CENTRE POINT  
PLANNING COMMENTS RESPONSE  
DOCUMENT 552-7101

22ND AUGUST 2012

This document highlights the proposed changes.

PROPOSED PLAN - LEVEL -01  
EXTRACT FROM 552-CPT-19601 REV PL2

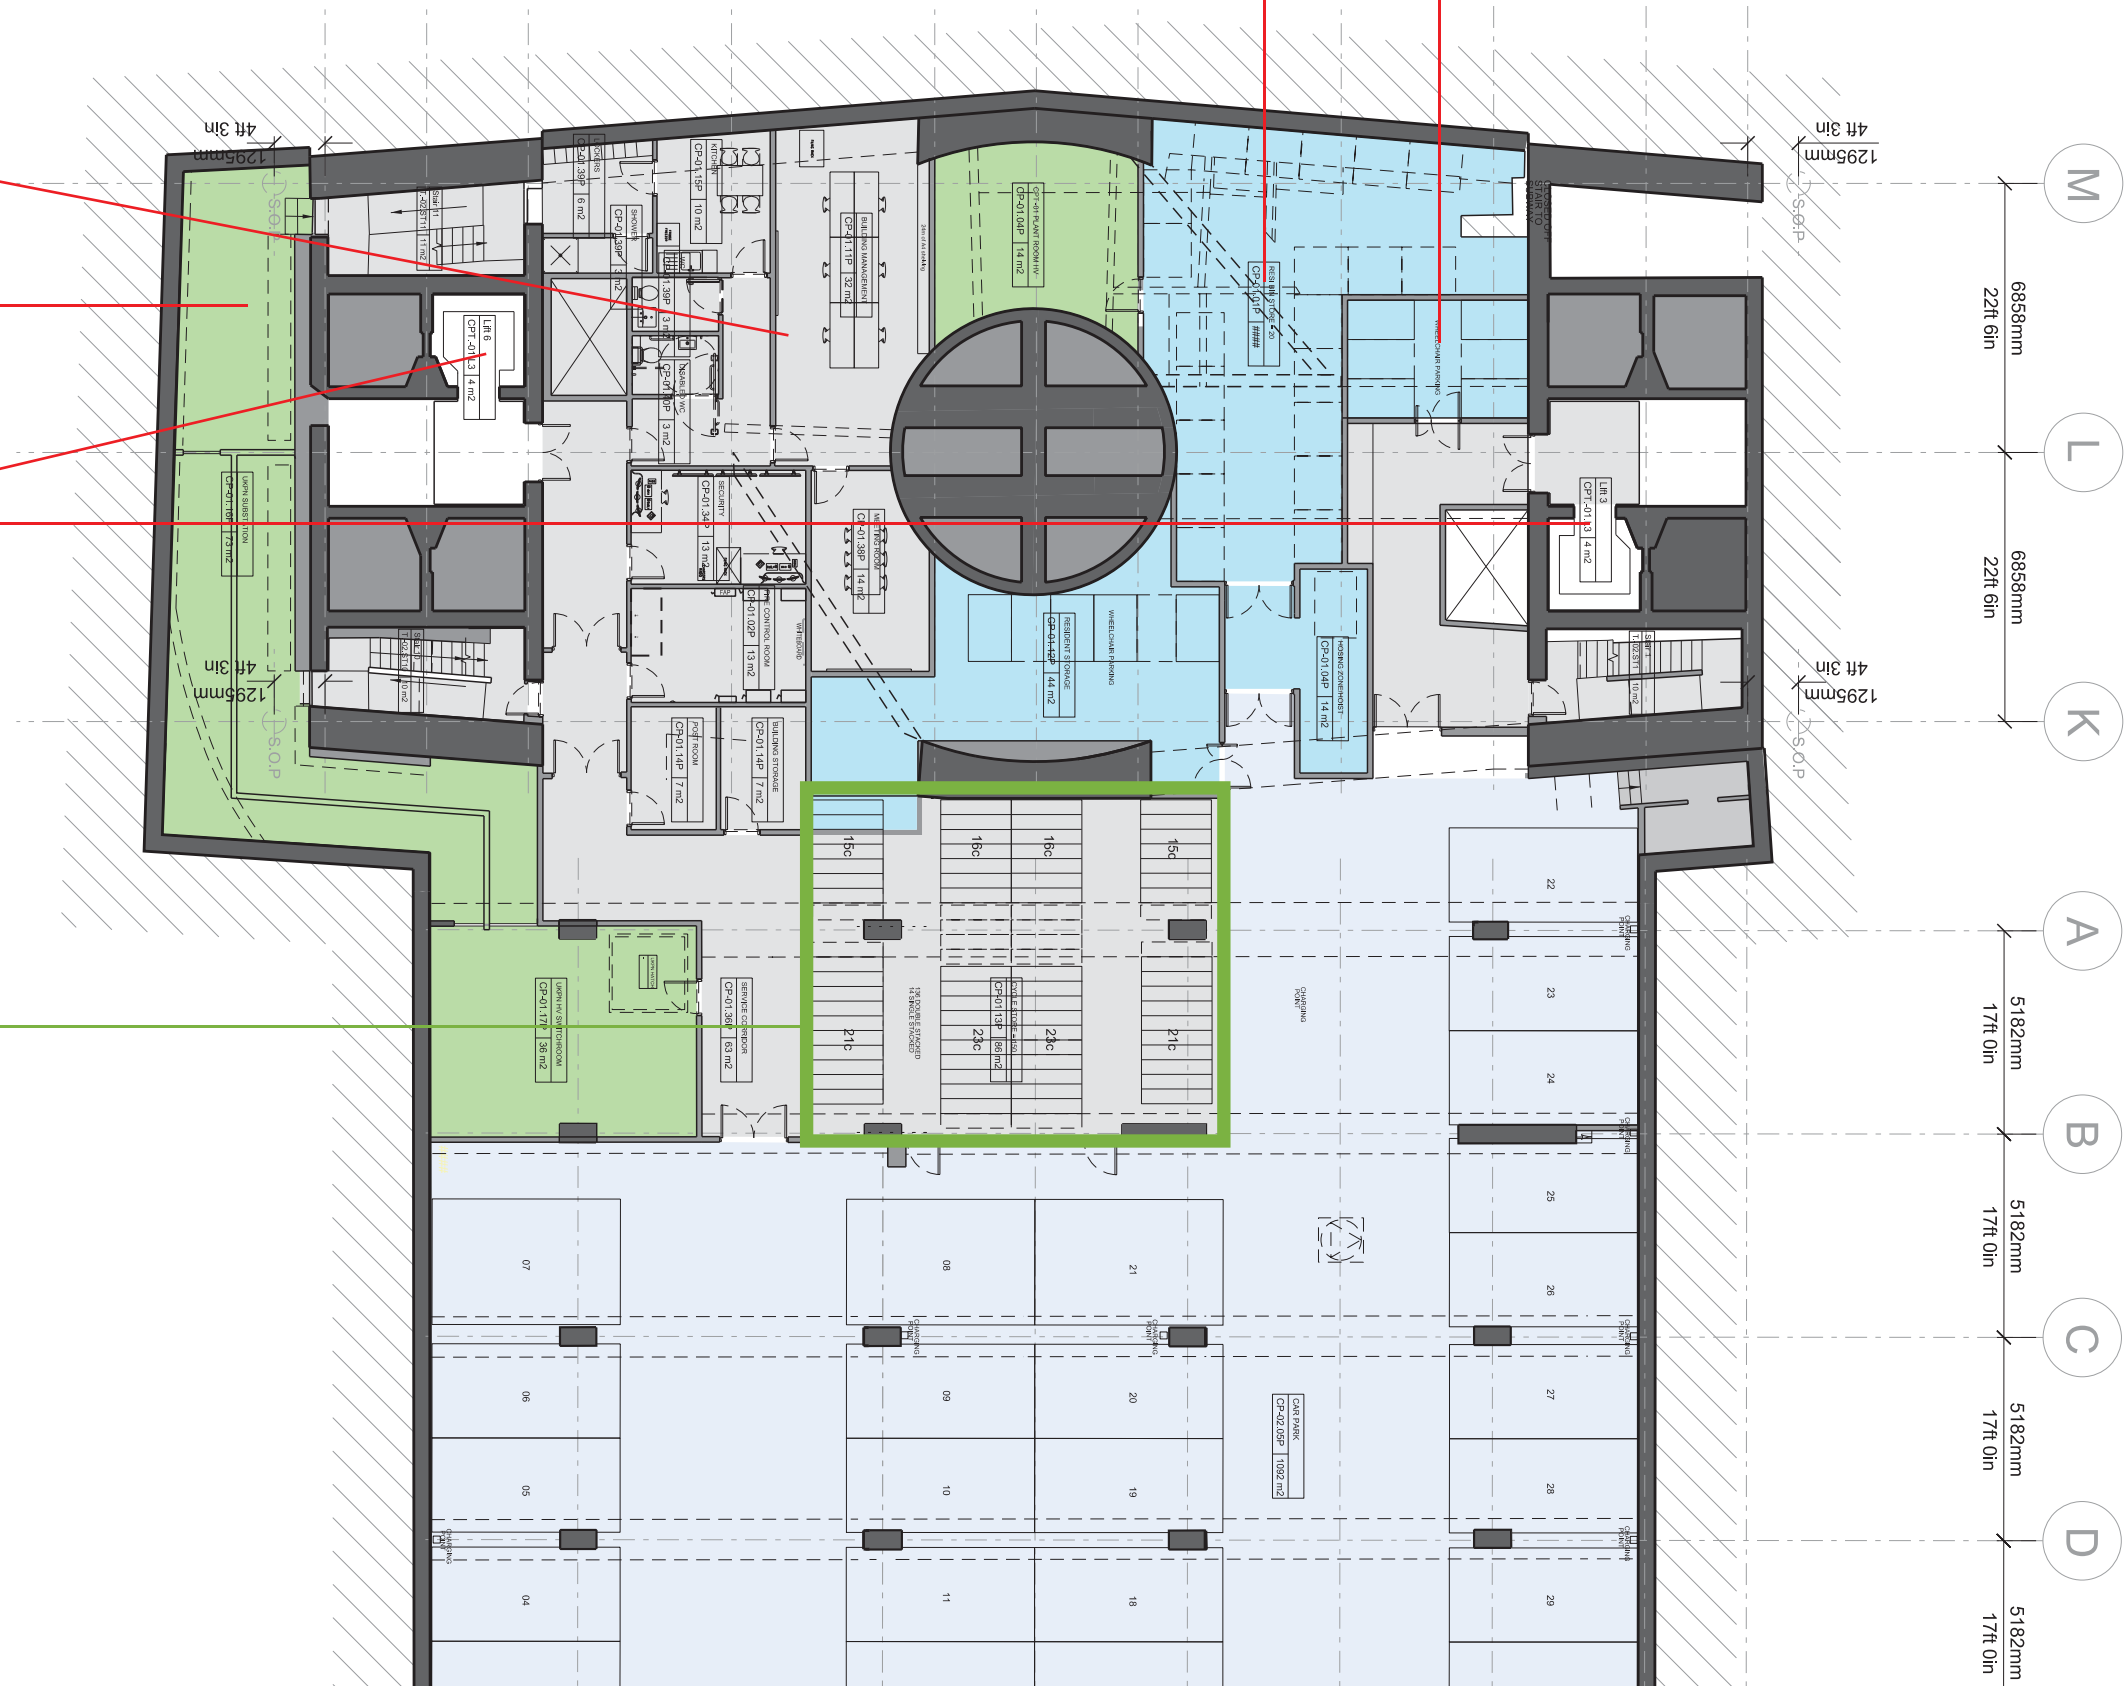
1. Modifications to room arrangements in basement around building management and plant areas to enable the extension of lift service for one lift in both the north and south cores of the tower downwards to serve level -1 of the basement. This removes the need for a separate lift to be added to connect ground floor lobby and basement levels.

2. Clarification of the bike storage facilities available as two secure rooms:

- Residential - 181 cycles
- Retail Staff - 31 cycles
- Retail Visitors -provision within public realm

**RESIDENTIAL STORAGE AREAS  
PROVIDE WHEELCHAIR CHARGING SPACE  
IS AVAILABLE AS REQUIRED**

**181 SECURE CYCLE STORAGE SPACES  
FOR RESIDENTIAL USE - USING DOUBLE  
STACKING 'BIKE DOCK SOLUTIONS' OR  
SIMILAR**

PROPOSED PLAN - LEVEL 04 (TYPICAL CPH FLOOR)  
EXTRACT FROM 552-CPT-19609 / 552-CPA-19502

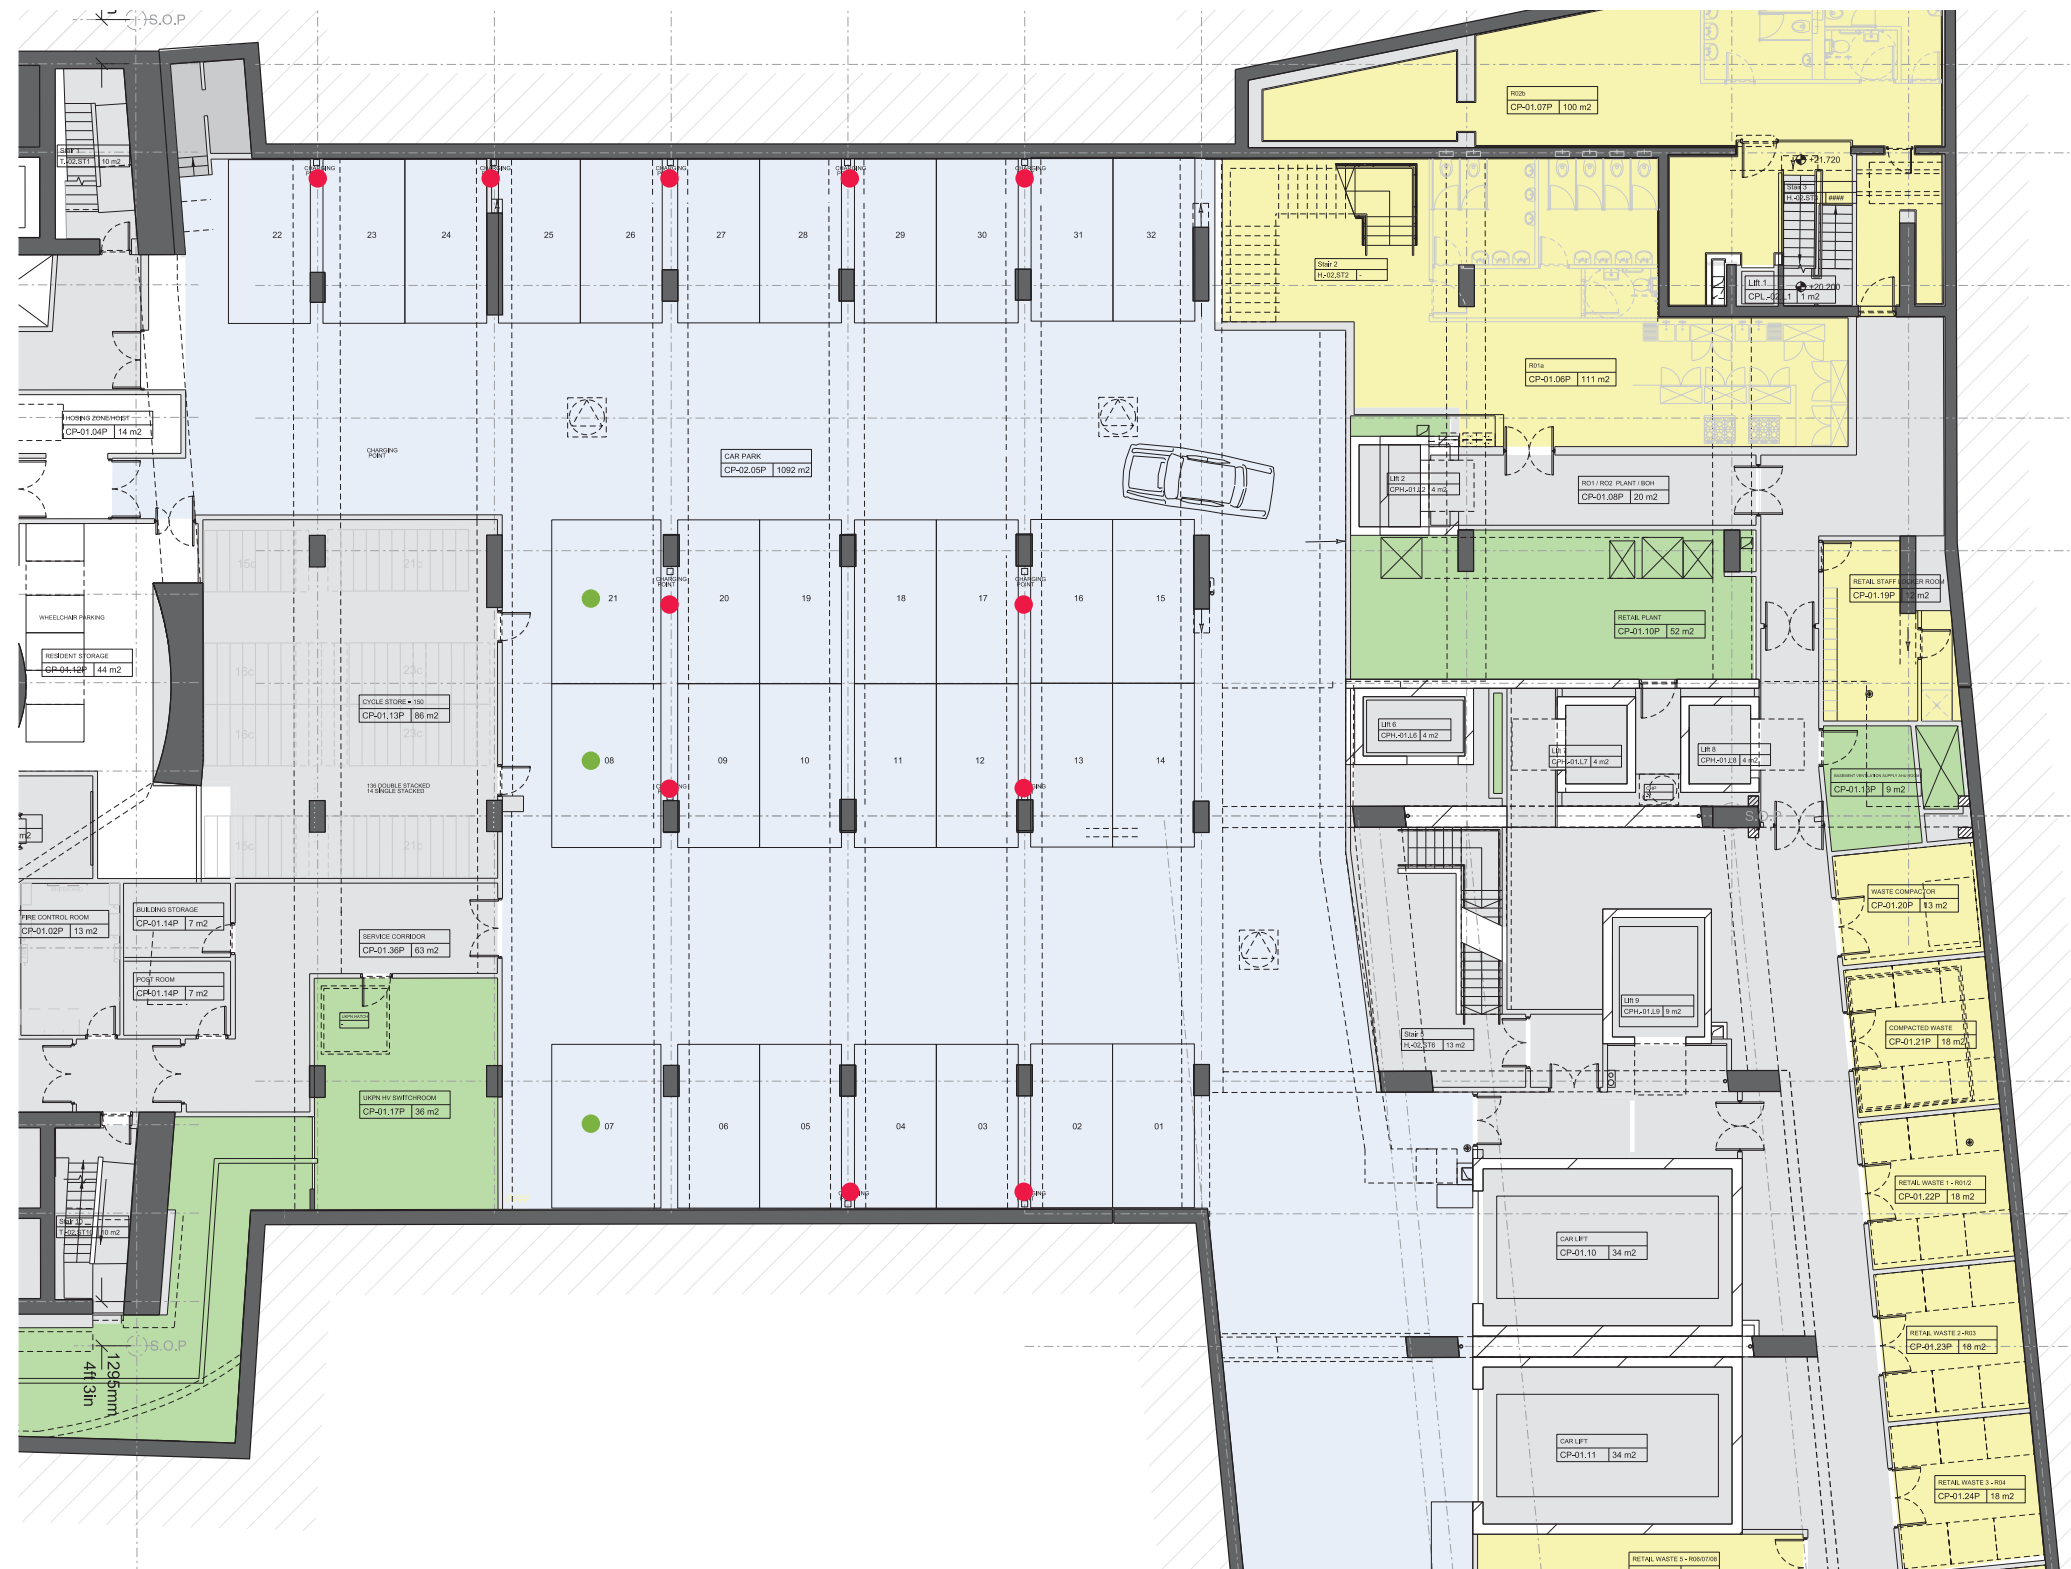
3. Design development of the ventilation duct to north side of Centre Point House. This has allowed the overall volume of the addition to be reduced to a more slender element. In addition a glazed 600mm wide slot has been introduced to preserve the sculptural quality but add more detail and articulation to the two planes to enliven the facade. Glazing areas have also been increased at the two sides of the plane.

MODIFICATIONS TO NORTH DUCT

REV PL1 NORTH ELEVATION

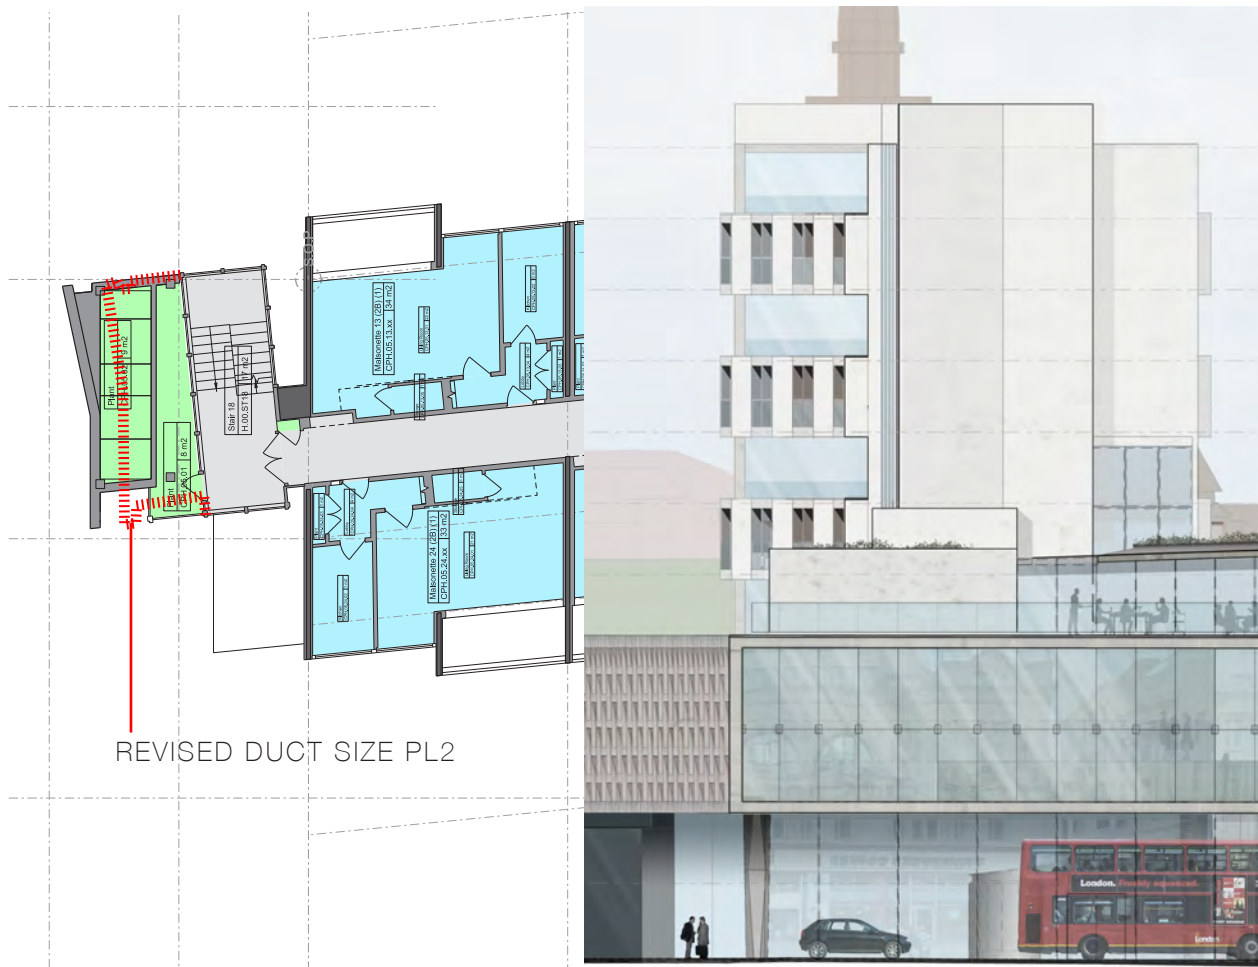
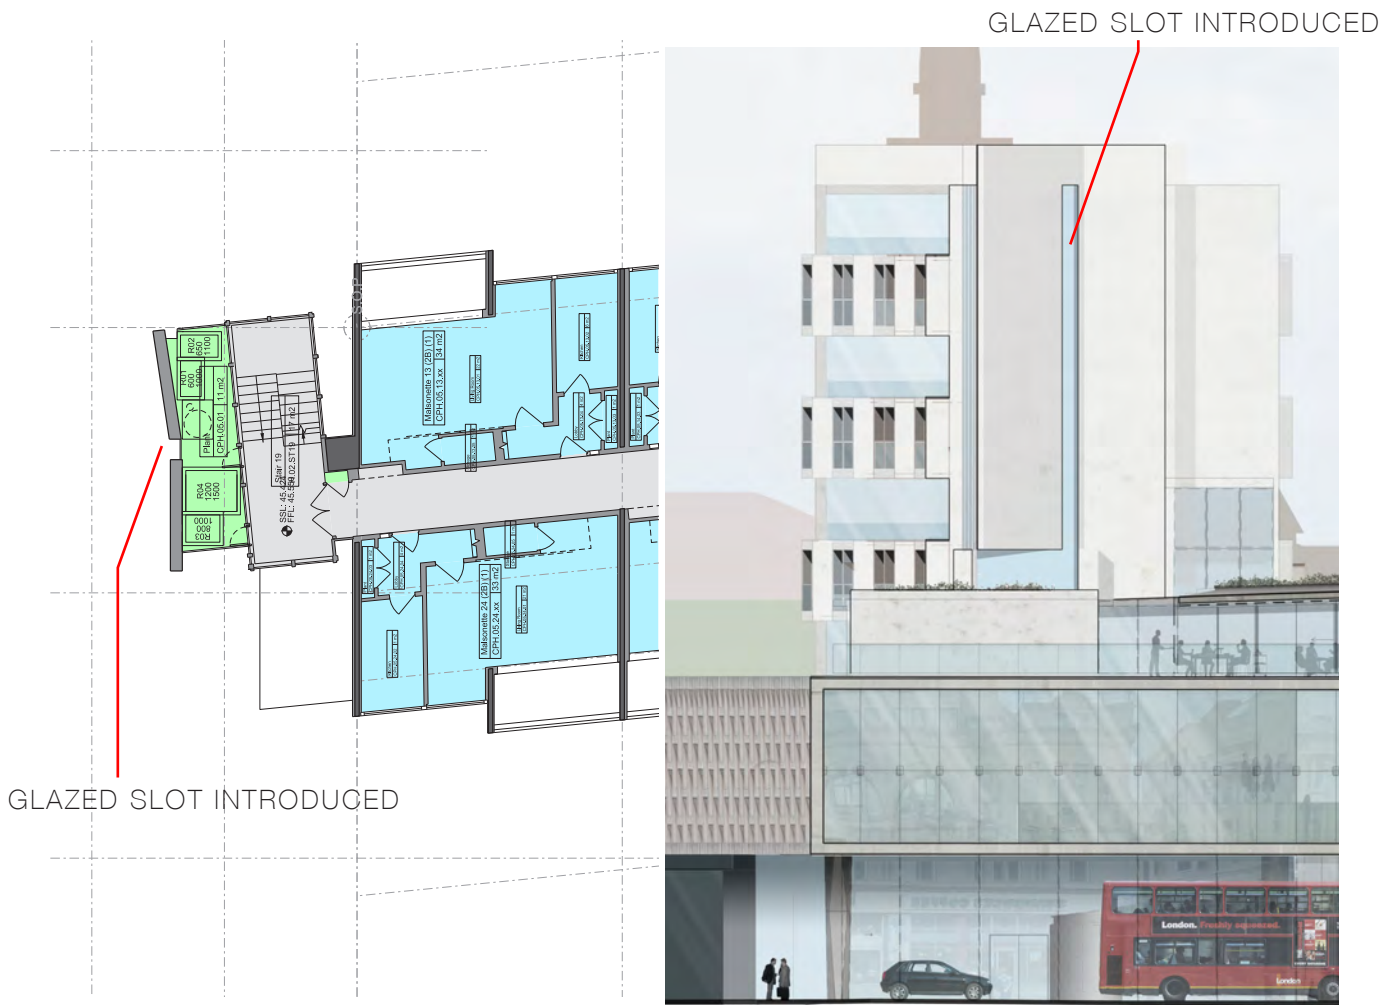
REVISED PROPOSAL (REV PL2) - REDUCED DUCT SIZE
